Ford Mondeo 2001 Models built up to 01/2002

Whistling noise from the heating system.

Bulletin

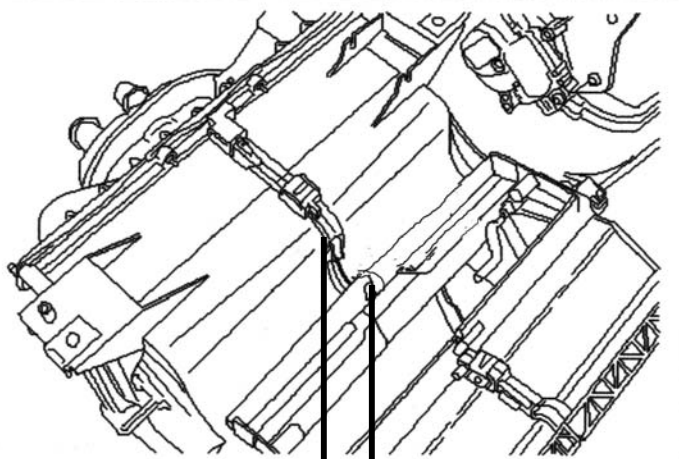
If there are faults about the above-mentioned fault, a possible cause could be an air gap between the two housing sections of the heat exchanger/evaporator housing. The noise is most clearly audible at fan speed 1 and 2 (2nd to 3rd fan speed graduation on electronic air conditioning) and disappears if the fan is switched off.

→ ← Area to be sealed (approx. 7 – 8 cm)

To eliminate the noise, the air gap at the heat exchanger/evaporator housing must be sealed. The area to be sealed is shown in the illustration below. In order to carry out the repair, the housing must be dismantled.
